RE: RESPONSE TO REQUEST FOR FURTHER INFORMATION UNDER CLAUSE 23(1) RMA ON A PRIVATE PLAN CHANGE REQUEST TO THE AUCKLAND UNITARY PLAN - FRANKLIN 2 PRECINCT

Franklin 2 Precinct – Private Plan Change

Response to Request for Further Information under Clause 23(1) RMA
Prepared for Grafton Downs Limited

Figure 1: Construction drawing for the Link Road being constructed as part of Designation No. 6311 Paerāta Station Interchange and Accessway

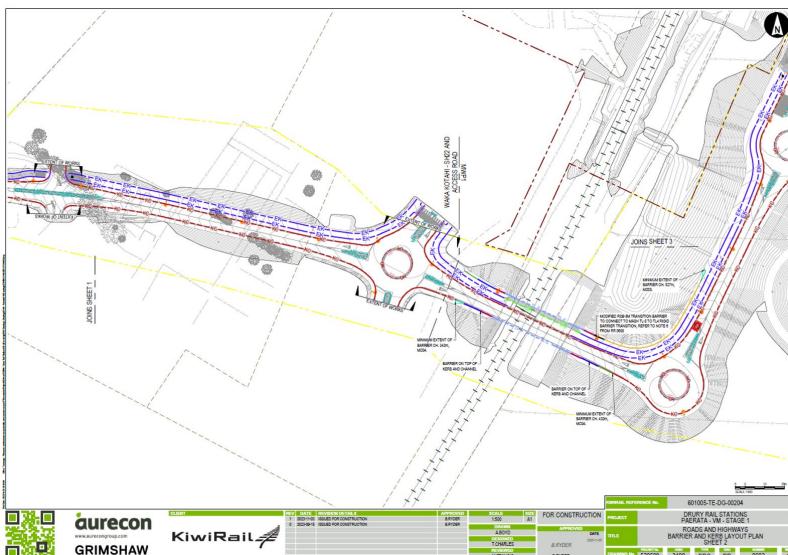
Please advise whether the indicative drawings contained in the Urban Design Plan set have taken account of the NZTA designation for the Link Road from SH22 and confirm the implications the designed street link will have on the urban structure and development pattern depicted in the drawings.

The urban design plan set has been developed taking into account the designation and design of the Link Road. The urban design approach in the precinct plans and the plan set ties in with the proposed block structure that integrates with the design of the Link Road. This ensures there is an efficient urban layout that maximises development and orientates blocks and local roads to achieve connected and accessible neighbourhoods and minimises rear lots. It can also achieve an appropriate interface to the boulevard type road that will carry traffic from SH 22 and could lead to the future Proposed Drury – Pukekohe Link Road.

It is understood that following the completion of the construction of the Link Road, a review will be undertaken to determine any areas that are no longer required for the long-term development, operation, or maintenance of the Link Road. This is evident in Figure 1 below, which shows the road design for construction with the wider designation boundary extent (shown with a yellow line), the Link Road occupies a significantly smaller area. Once completed, the block/lot boundaries can be adjusted during the detailed design stage, though the overall block structure is already established.
